**ADDENDUM NO. 1**

**AUTOMATED PEOPLE MOVER OPERATING SYSTEM  
SUPPLIER ELIGIBILITY DETERMINATION**

**LANDSIDE ACCESS MODERNIZATION PROGRAM**

**LOS ANGELES INTERNATIONAL AIRPORT**

- SHEET NOTES:
1. SEE SHEET ED-01 FOR GENERAL NOTES.
  2. SEE GEOMETRIC DATA TABLE ON SHEET ED-17 FOR ADDITIONAL TRACK GEOMETRY.
  3. SGL ELEVATIONS SHOWN IN THESE DRAWINGS ARE HIGH POINTS OF THE DECK. ELEVATIONS WILL VARY FOR STRUCTURAL DECK DRAINAGE.

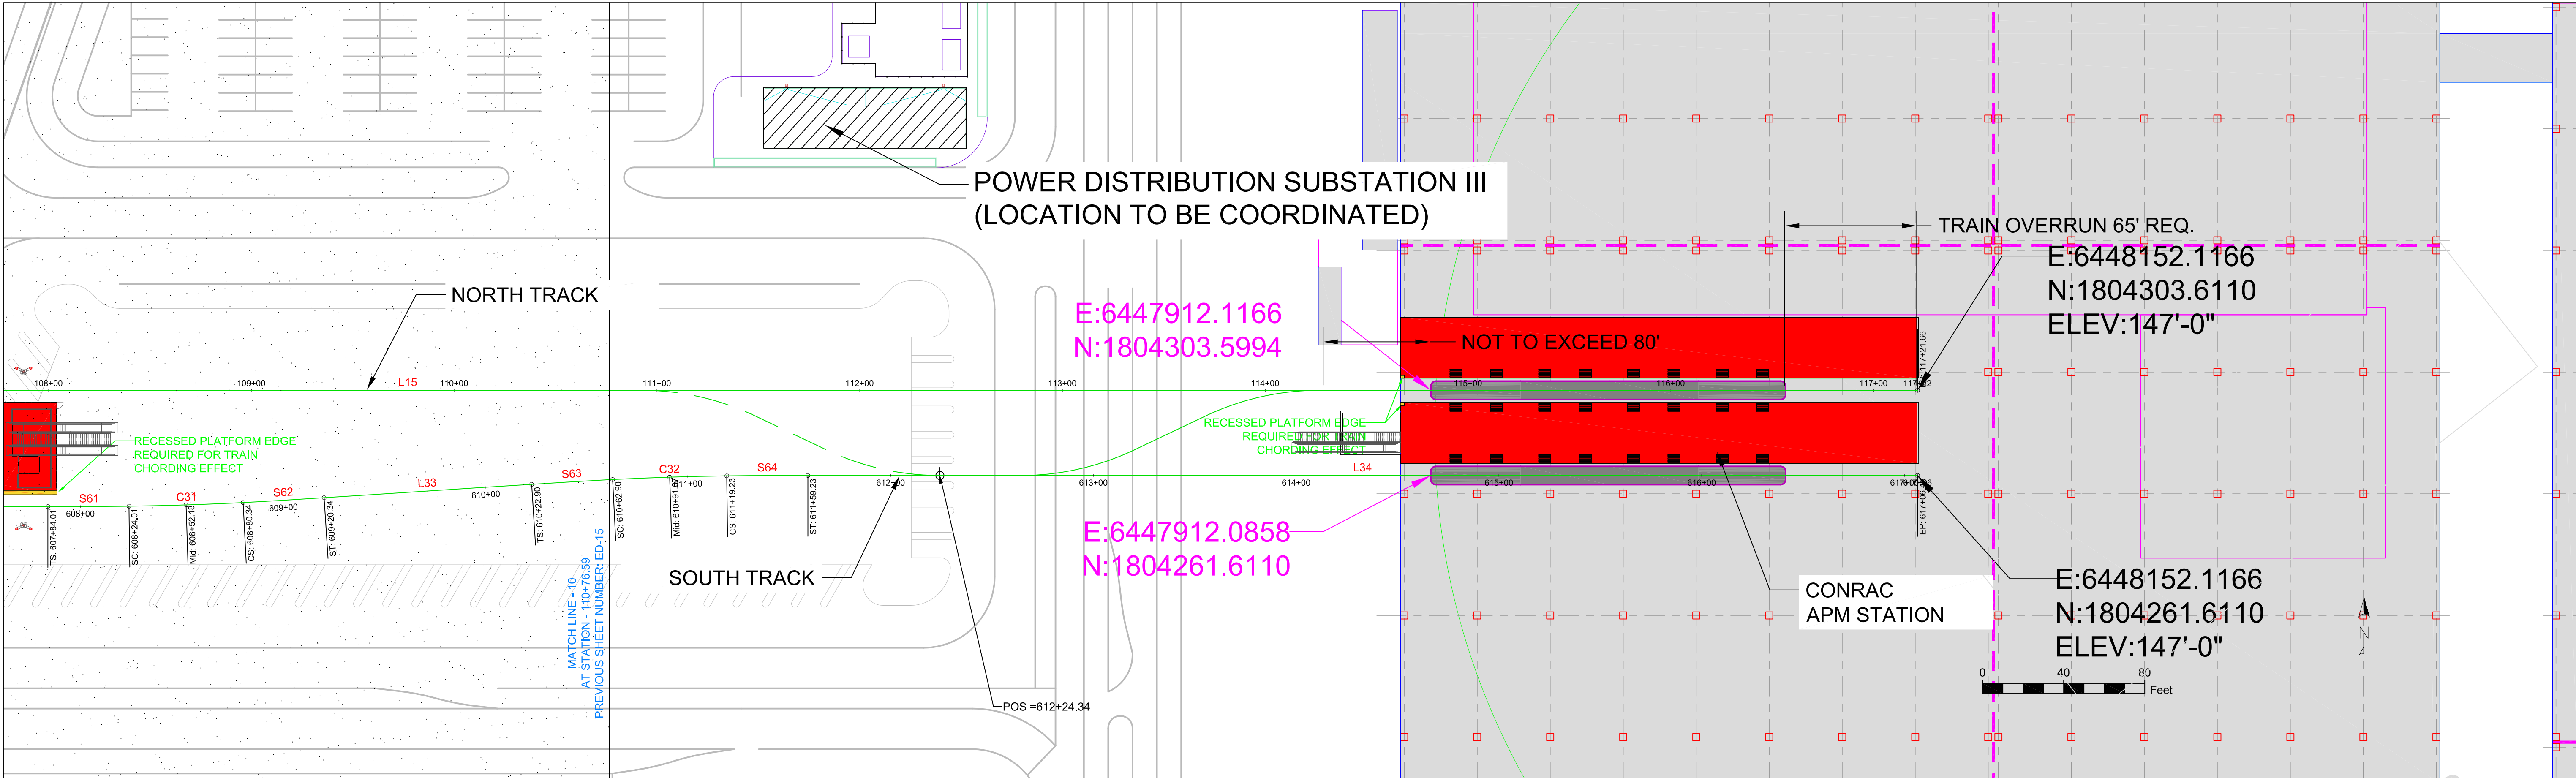
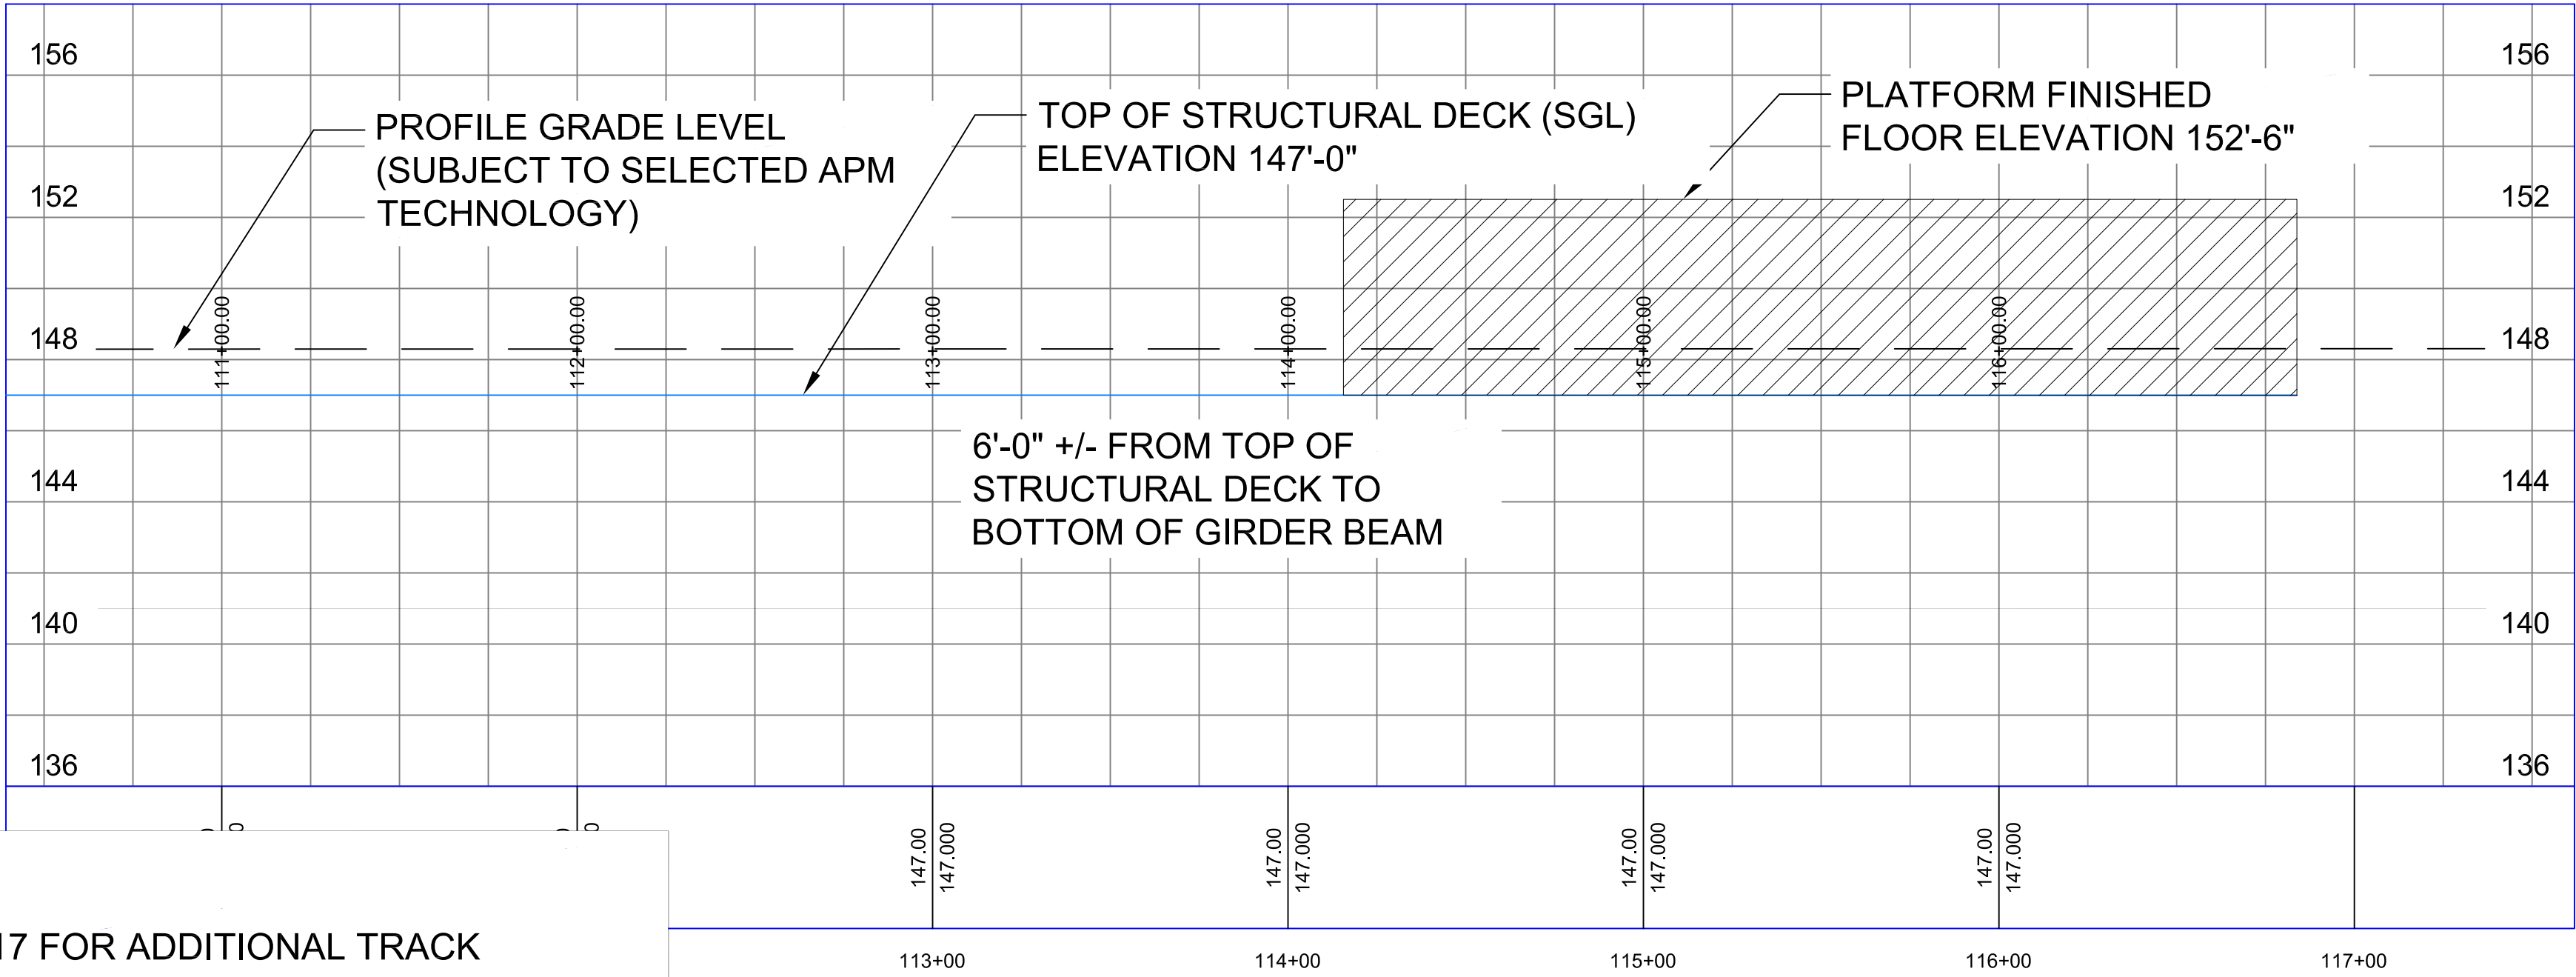
**RFC 5 :** Attachment 4 – Sheets ED-17 and ED-18. We reviewed and re-created the alignment stationing and find that there is a discrepancy between the alignment stationing (created from the curve data) and the alignment stationing shown on sheets ED-09 through ED-16. A similar discrepancy is observed on Sheets ED-03 through ED-05. Please clarify.

- a. Replace sheets ED-04, ED-05, ED-09 through ED-16, and ED-19 with attached sheets ED-04, ED-05, ED-09 through ED-16, and ED-19, Addendum 1 – May 5, 2016. Revised sheets incorporate a correction to the stationing on the sheets.

**RESPONSE 5:** Refer to the revised Sheets ED-04, ED-05, ED-09 through ED-16, and ED-19 for Attachment 4 in Addendum 1 – May 5, 2016.

PROFILE OF LIGHT MAINTENANCE TRACK 1 ONLY

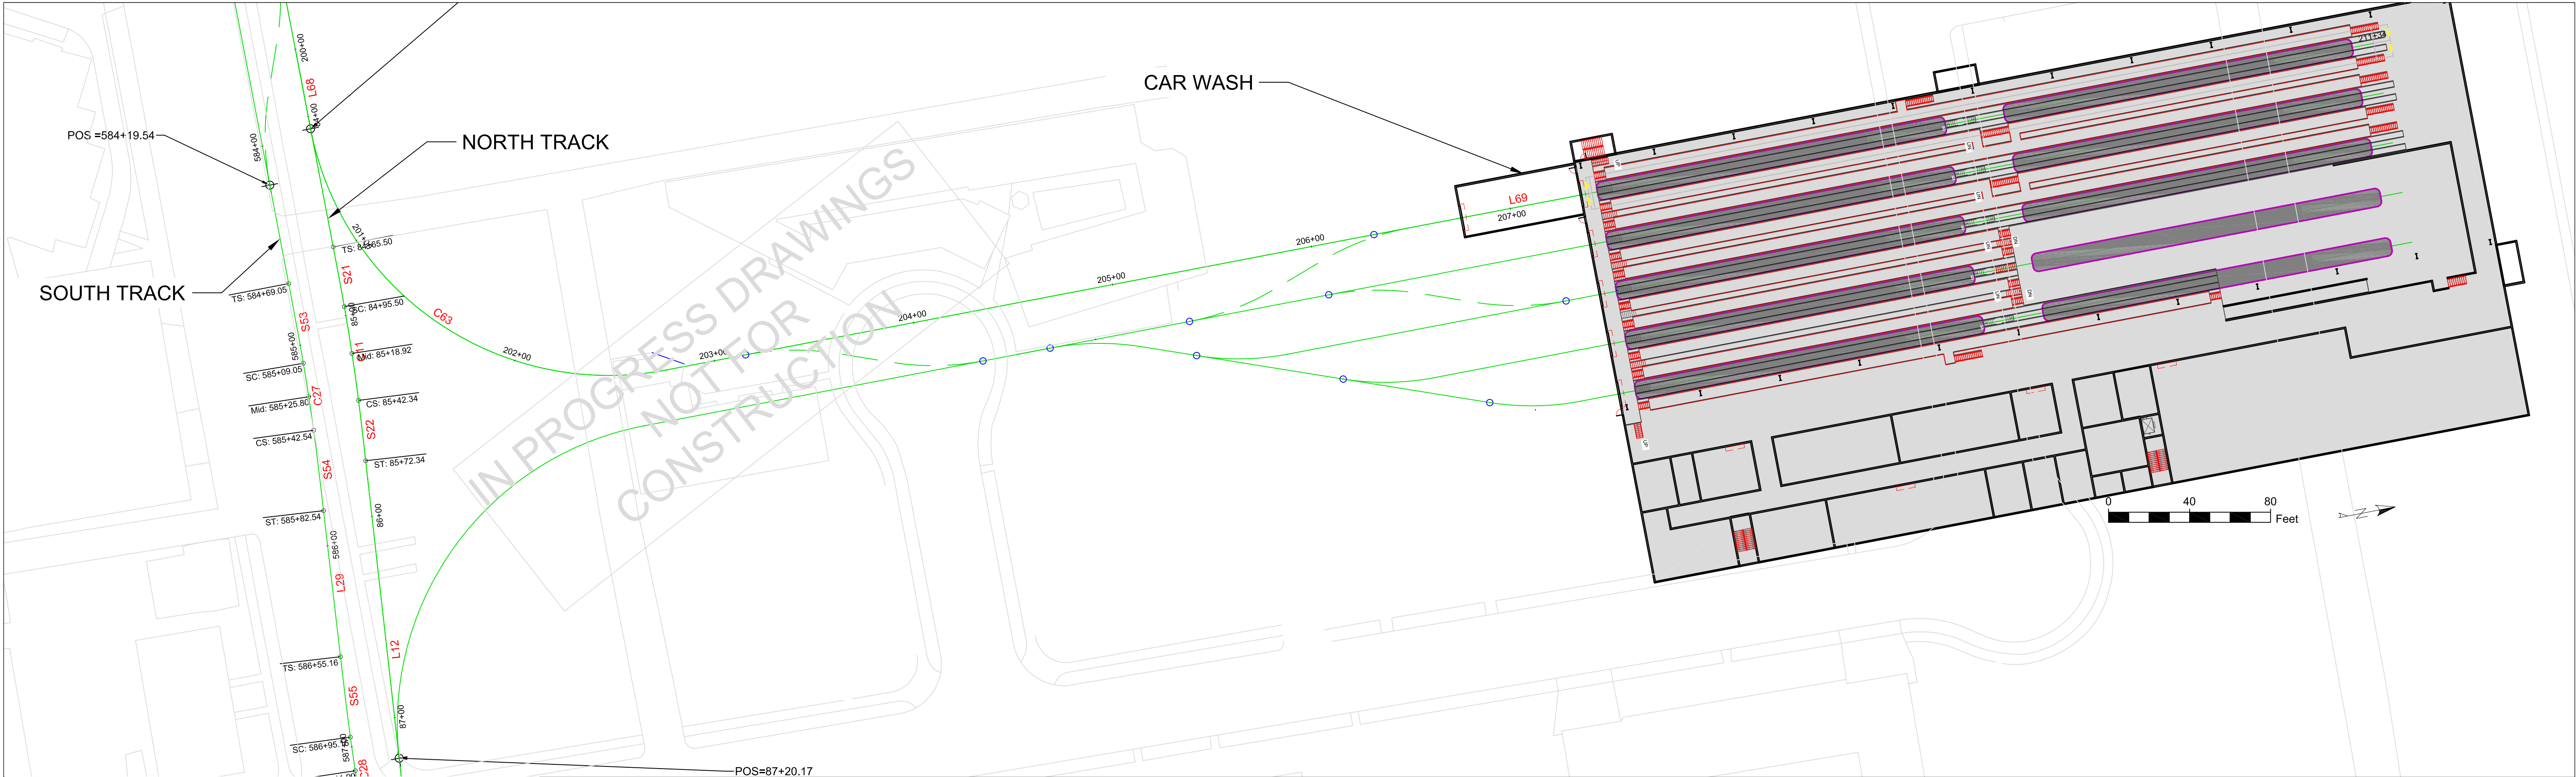
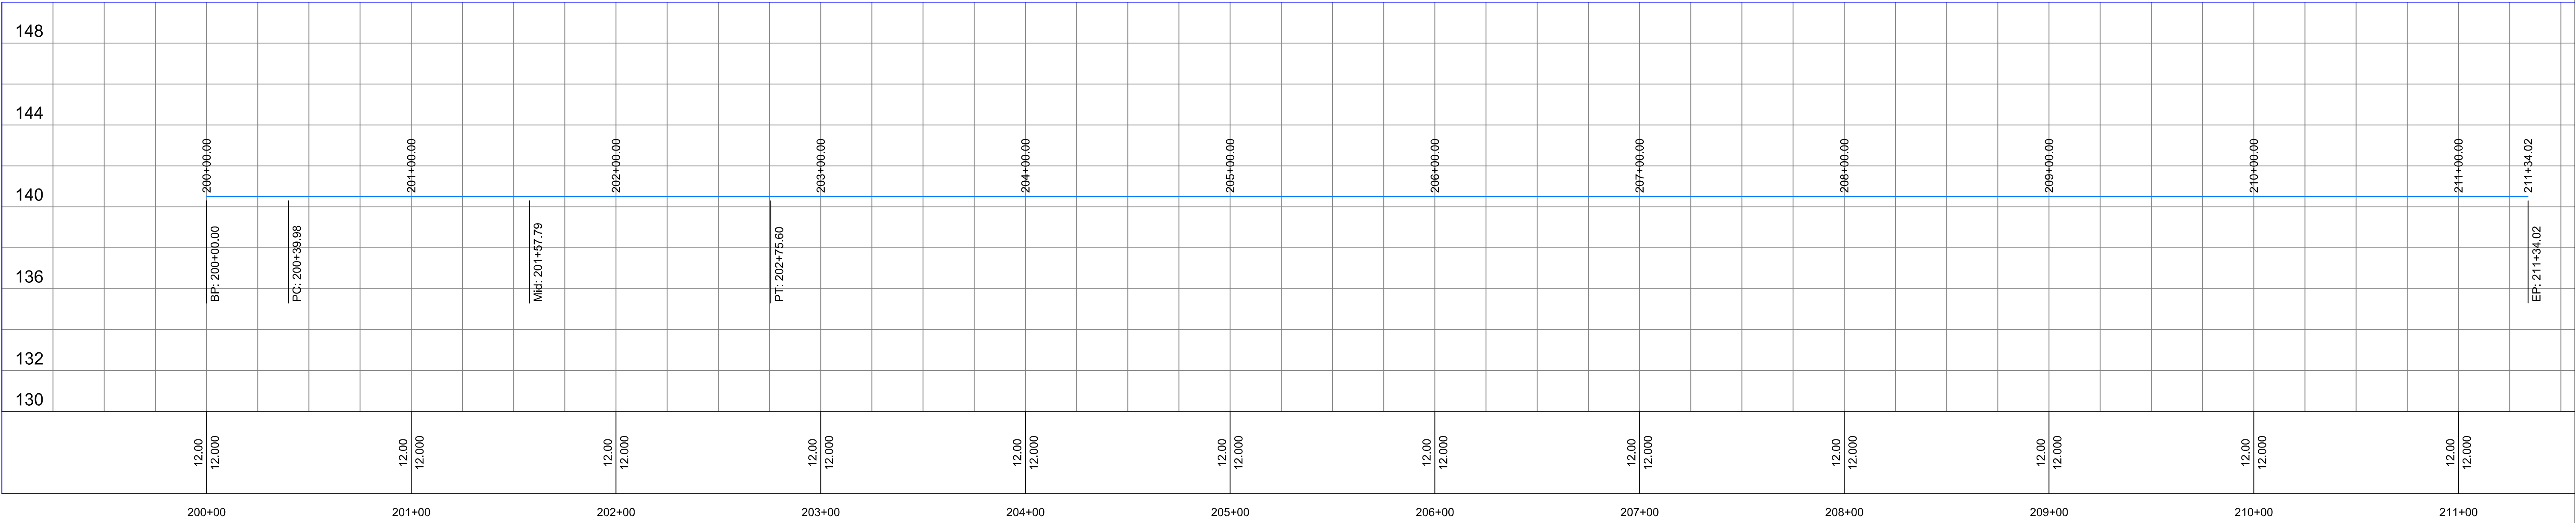
**RFC 4:** Attachment 4 – About the identified geometry for the Light Maintenance Track 1 on Sheet ED-19 in Attachment 4: The Start and End coordinate points (L68 and C63) provided in the table do not allow enough space to place a 150 foot radius curve, if 150 foot radius curve is the LAWA required radius in that position. Please confirm the provided coordinate data. In addition, will additional geometry information be provided for Light Maintenance Track 2?

**RESPONSE 4:** Provided coordinate data is confirmed. Also see response to Request for Clarification No. 5 and provide specific details to clarify your question. Also, geometry for Light Maintenance Track 2, if required by the eventual supplier/developer team, shall be established by that team substantially within the conditions shown in the drawings. Note that a Request for Proposals expected to be issued in the future is anticipated to require integrated proposals (incorporating both the fixed facilities/infrastructure and the operating system).
